Supplementary Information

**Proposed Temporary Place of Recreation, Sports or Culture (Hobby Farm and Fishing Ground),
Holiday Camp, Barbecue Site and Animal Boarding Establishment with Ancillary Facilities and
Associated Filling of Land for a Period of 3 Years in "Agriculture" Zone,
Various Lots in D.D.135 and Adjoining Government Land, Pak Nai, Yuen Long, New Territories**

(S.16 Planning Application No. A/YL-PN/91)

Departmental Comments	Applicant's Responses
Comments of the Chief Engineer/Mainland North, Drainage Services Department (Contact Officer: Mr. Daniel CHAN; Tel: 2332 2471)	
Comments received on 6.5.2026

DWG. TITLE FILLING OF LAND	
DWG NO. PLAN 5	VER. 001

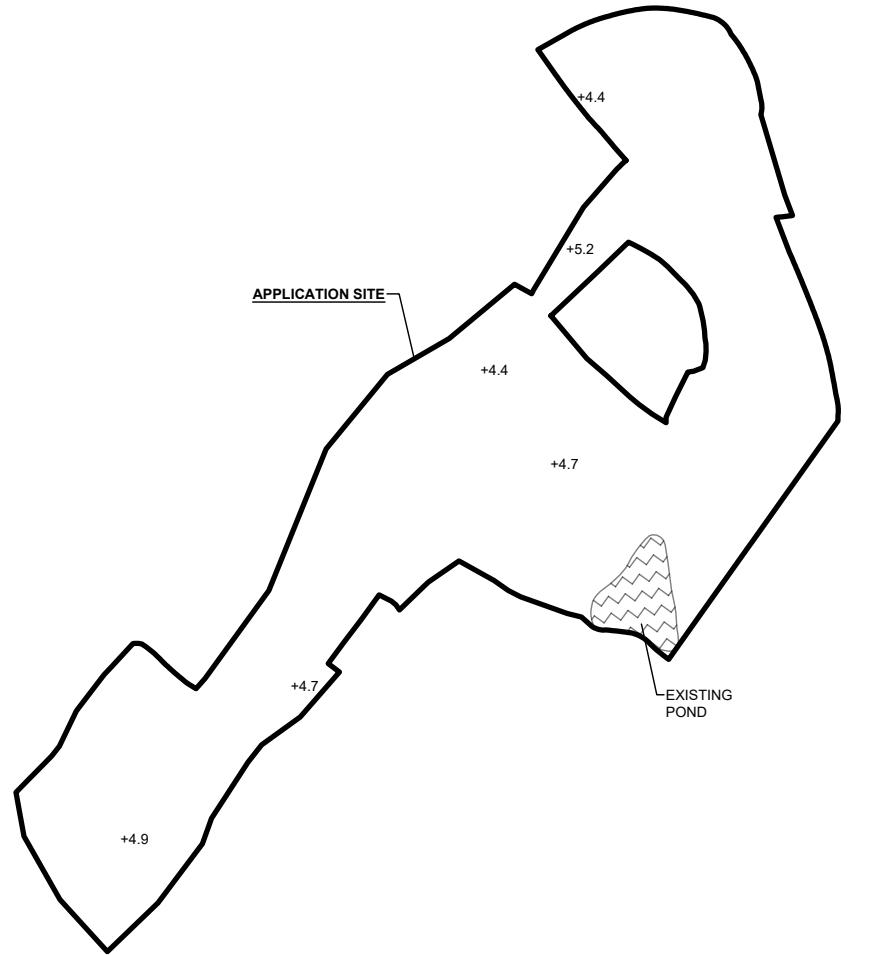
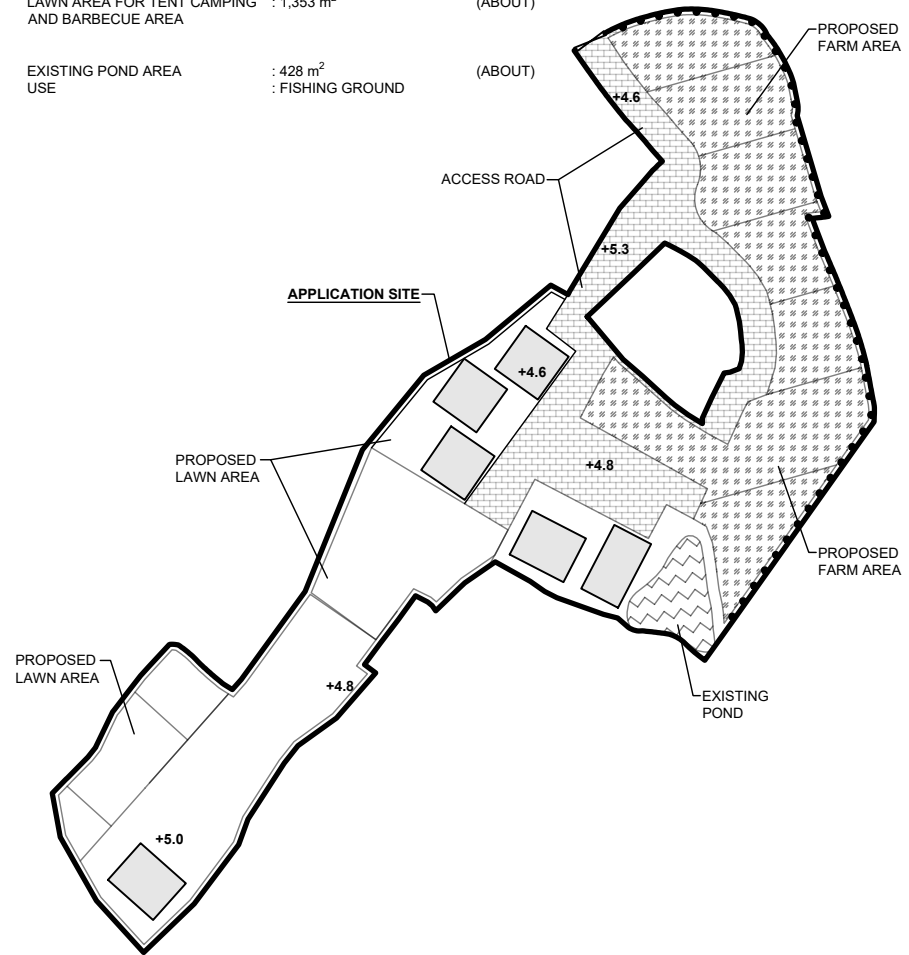
- (a) The revised plan and appendices are provided, details are as follows:
- Land filling plan (**Plan 5**)
 - Replacement page of tree survey (**Appendix I**)

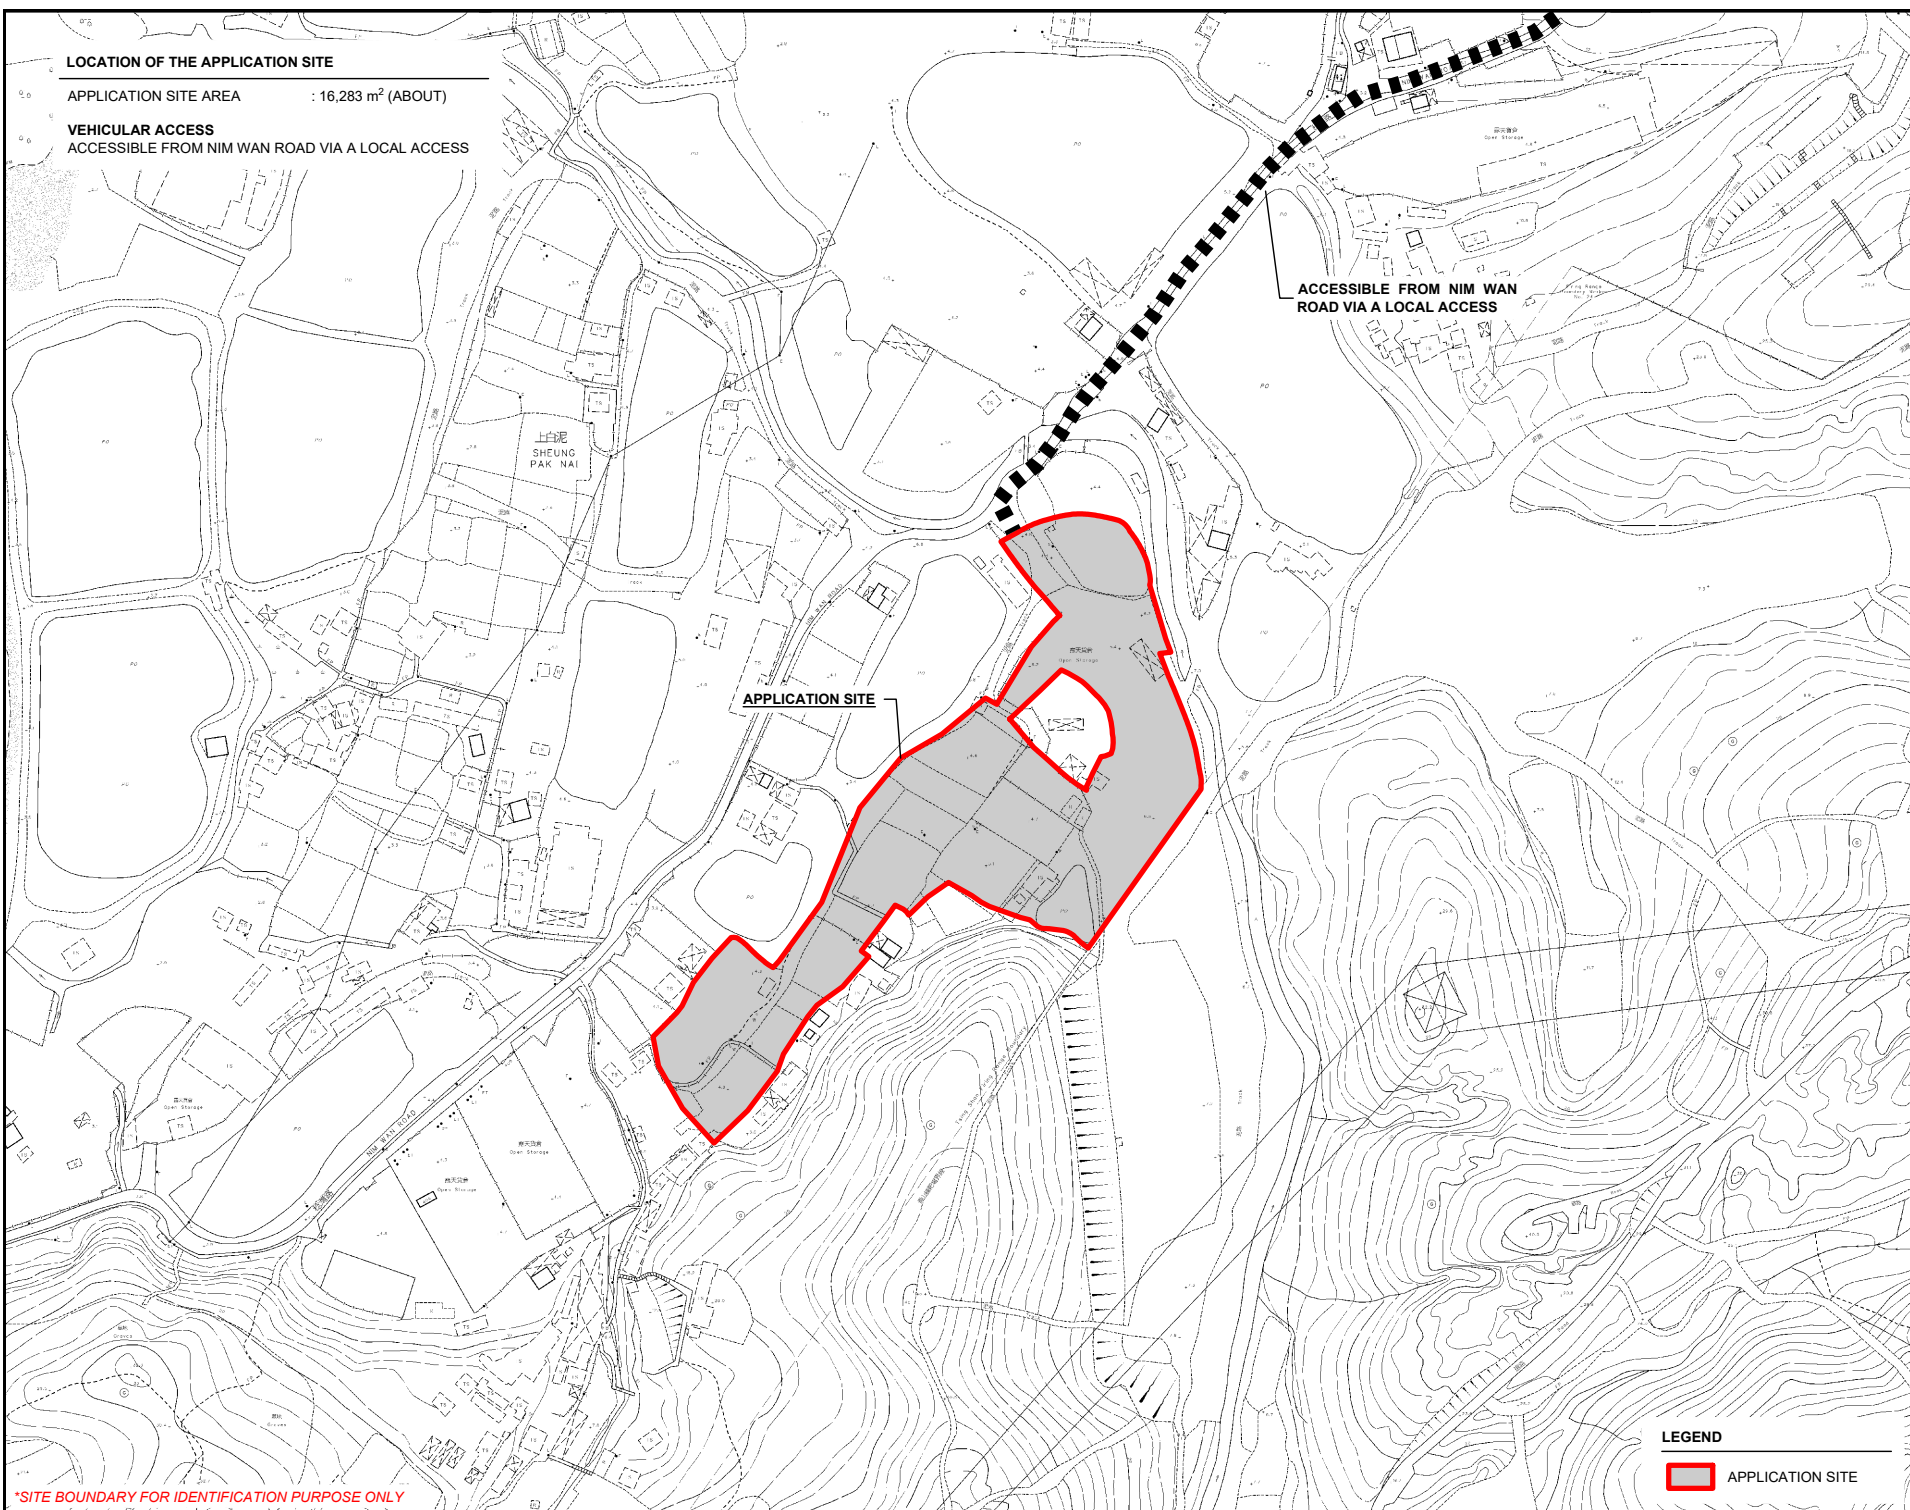
(a) Section 2.1.3 - Figure 2 was not provided in the submission.	Section 2.1.3 is revised. The existing stream is highlighted on Drawing No. PLAN 3 in Appendix A for clarity.

2.1.3 There are existing watercourse surrounding the proposed site, collecting runoff near Nim Wan Road which has generally higher ground level. The proposed site is minimum 3m away from the existing watercourse. The existing stream is highlighted on Drawing No. PLAN 3 in **Appendix A** for clarity.

DWG. TITLE
LAYOUT PLAN

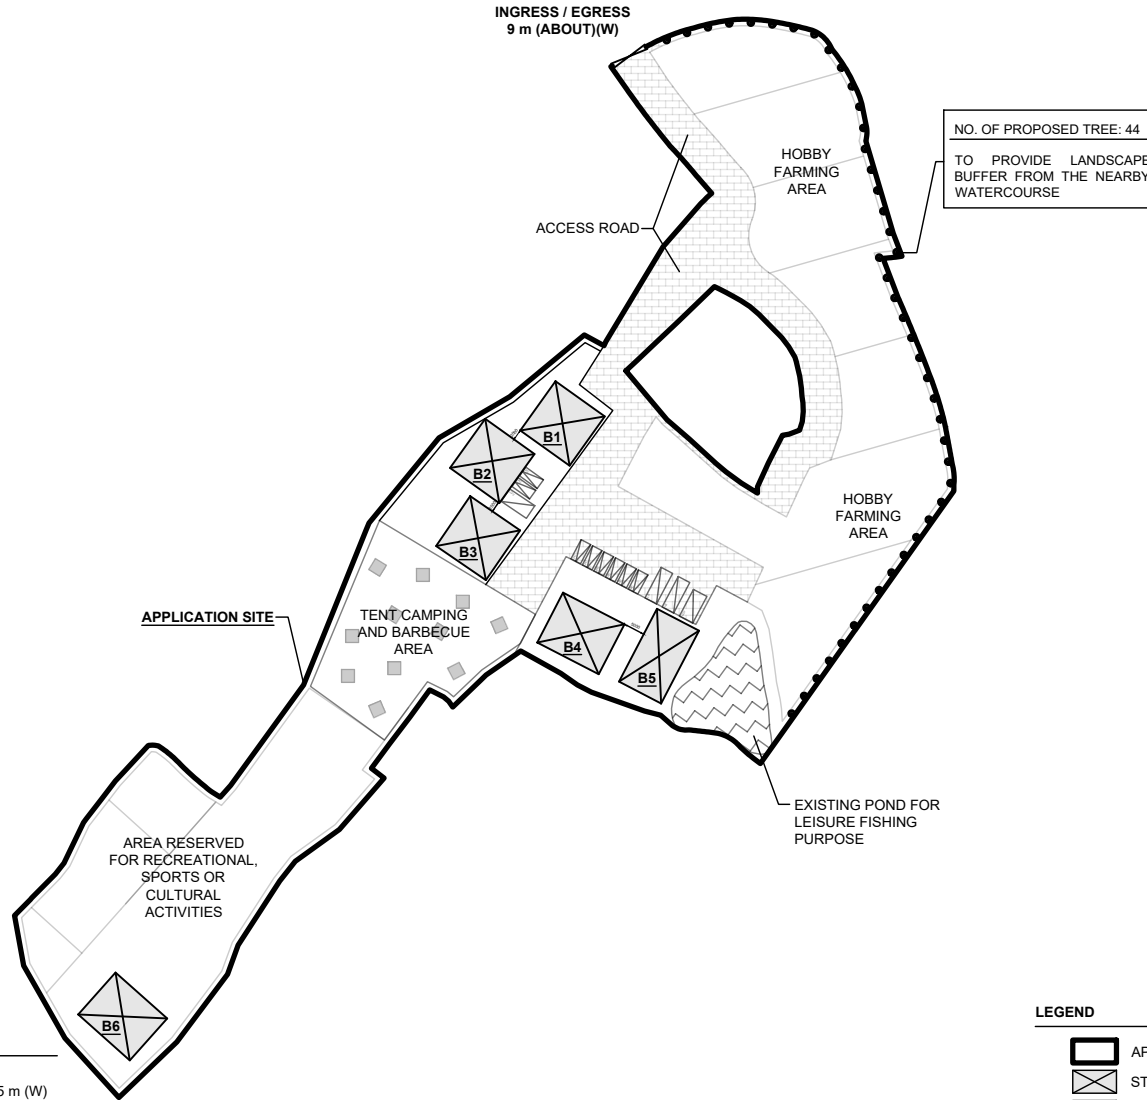
(b) Section 2.2.1 - Plan 9 was not provided in the submission.	For the master layout plan, please refer to Drawing No. PLAN 4 in Appendix. Section 2.2.1 is revised accordingly.

DRAINAGE LAYOUT

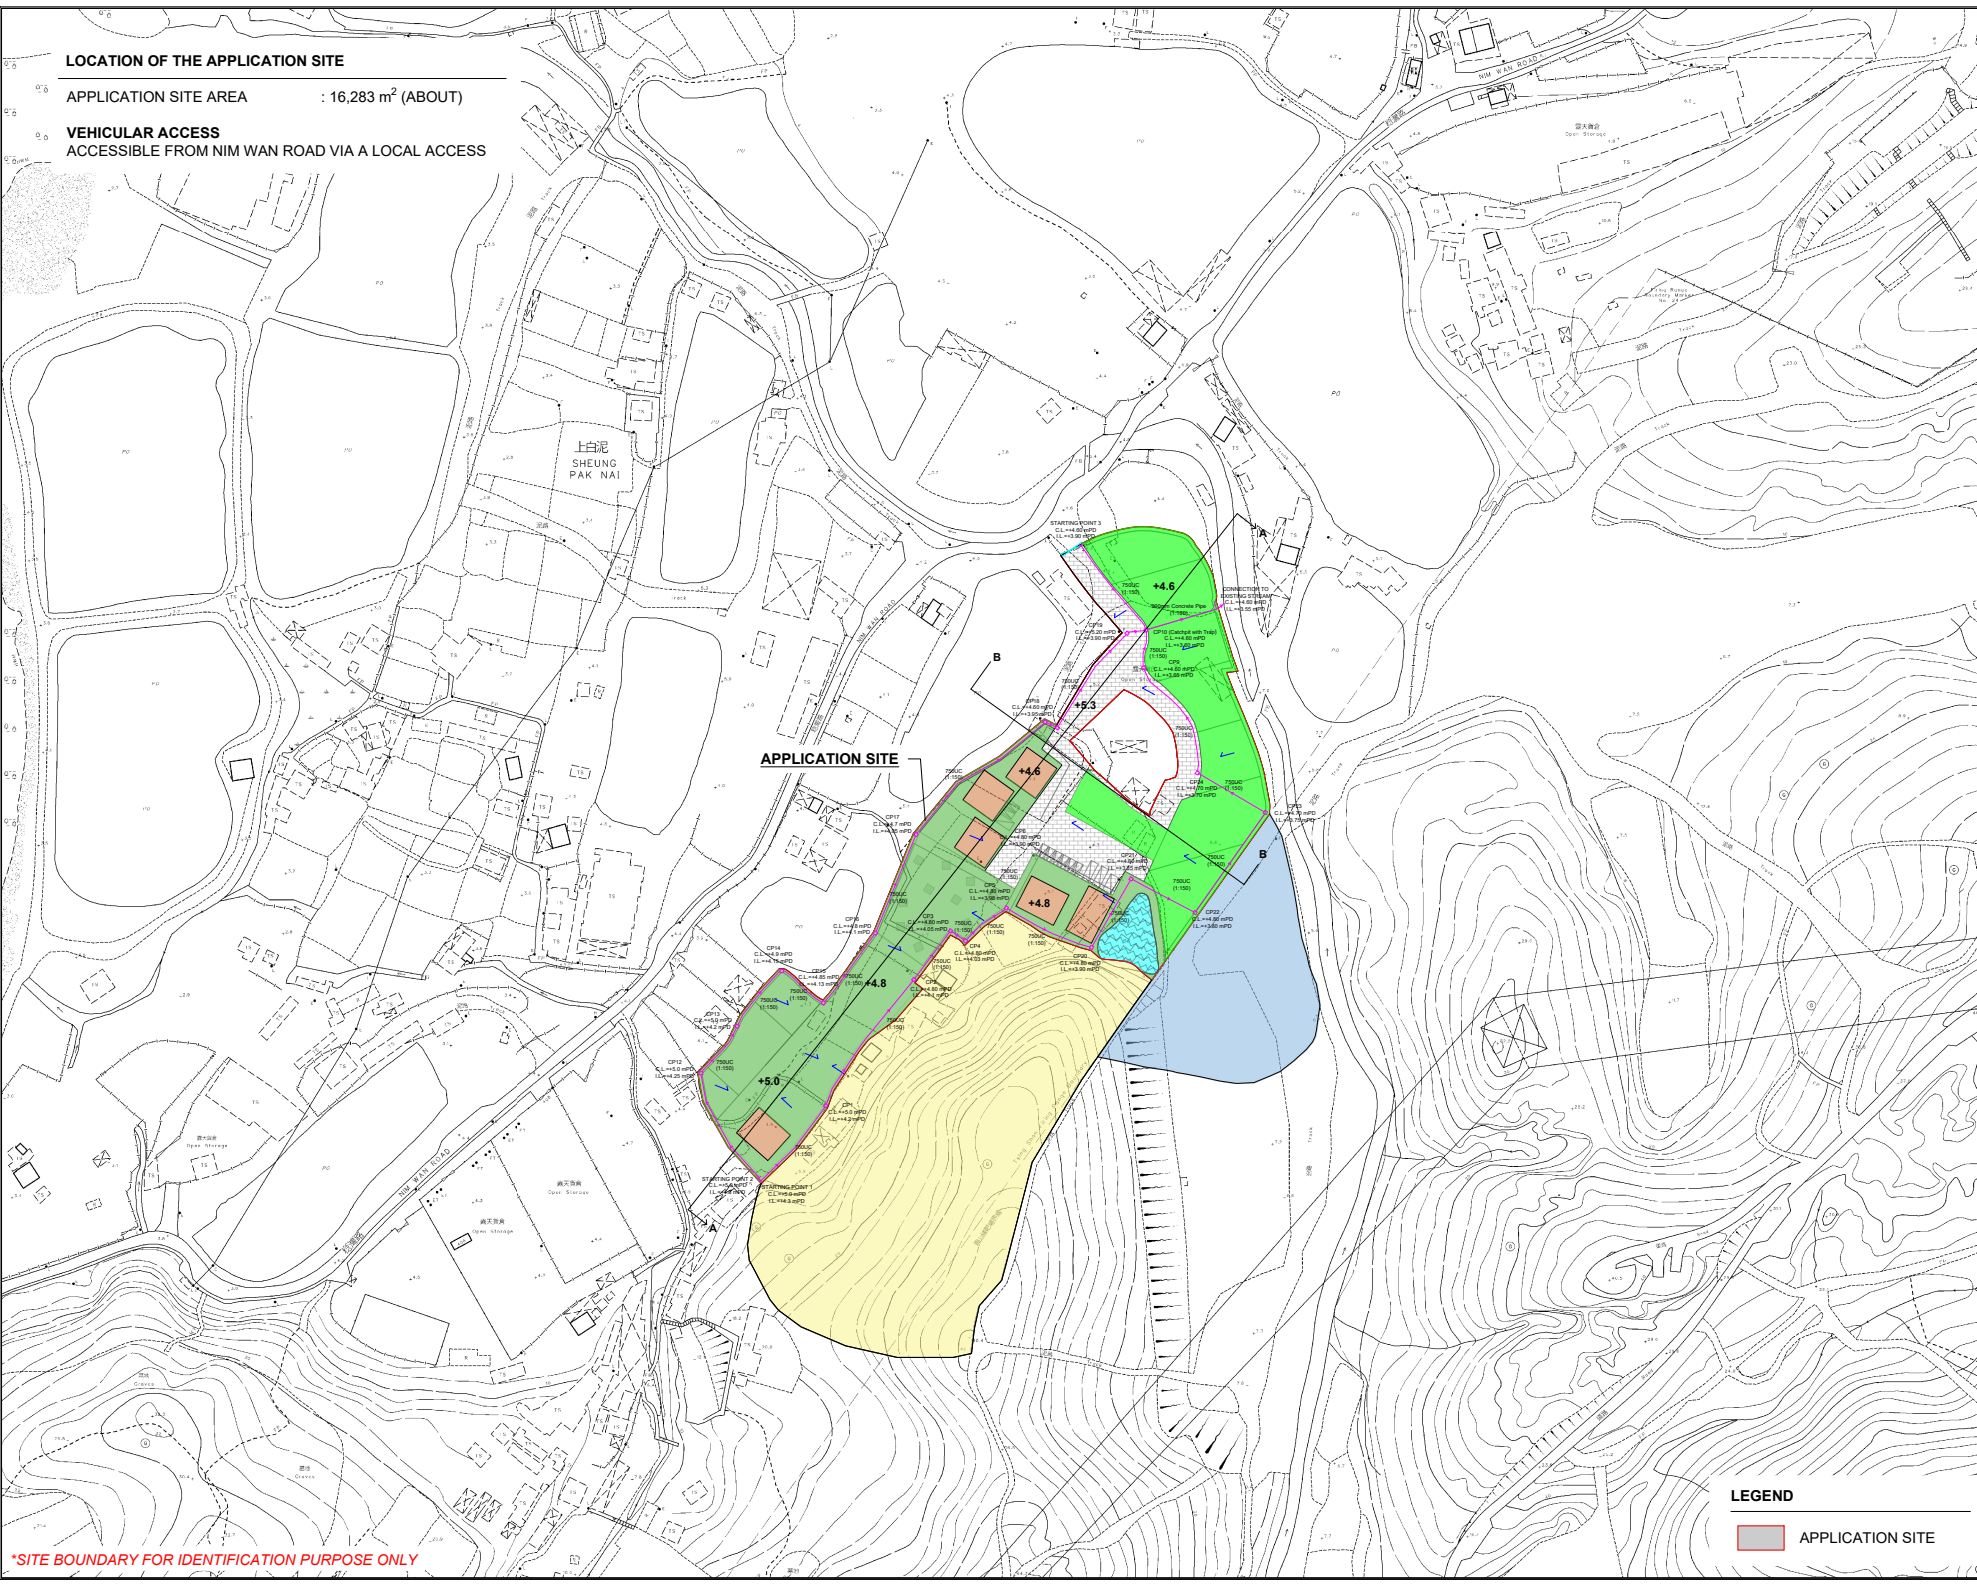
(f) Peripheral surface channels shall be provided along the site boundary of the	U channels have been provided along site boundary at the lower sides

<p>lower sides to collect the surface runoff accrued on the application site and to intercept the overland flow from the adjacent lands.</p>	<p>to collect the surface runoff accrued on the application site and to intercept the overland flow. Please refer to drawing no. DIA1. Please refer to the revised drainage layout, Drawing No. DL1 in Appendix A.</p>
<p>(g) Cross sections showing the existing and proposed ground levels of the captioned site with respect to the adjacent areas should be given, as well as the connection / discharge details from proposed site to the existing stream.</p>	<p>Noted. Drawing No. CS1 is included to show cross sections of the existing and proposed ground levels of the captioned site as well as the drainage details from the proposed site to the existing stream.</p>
<p>(h) Drg No. DIA 1 - It is noted that the site at south of Catchment A2 outside the site is higher than A2, and it is expected that surface runoff might flow passing through the site. In addition, the lot DD135 Lot 35 was excluded from the concerned site. However, the site area of Lot 35 should be taken into account in the concerned catchment. Please review the catchment.</p>	<p>An external catchment E2 is included on Drawing No. DIA1 in Appendix A to cater the potential runoff from the south of Catchment A2.</p>

<p>(i) Sand trap or provision alike should be provided before the collected runoff is discharged to the public drainage facilities.</p>	<p>A catchpit with trap would be provided at the last catchpit before discharging to the existing stream. Please refer to Drawing No. DL1.</p>
<p>(j) Where walls or hoarding are erected are laid along the site boundary, adequate opening should be provided to intercept the existing overland flow passing through the site.</p>	<p>Noted.</p>
<p>(k) The development should neither obstruct overland flow nor adversely affect existing natural streams, village drains, ditches and the adjacent areas, etc.</p>	<p>Noted.</p>
<p>(l) Consideration should be given to provide grating for the surface</p>	<p>Steel Grating would be provided for the proposed U-channel. Standard Drawing No. is included in Appendix E.</p>
<p>(m) Appendix D - the location of photo 4 is unknown.</p>	<p>The location of photo 4 has been provided in Appendix D.</p>
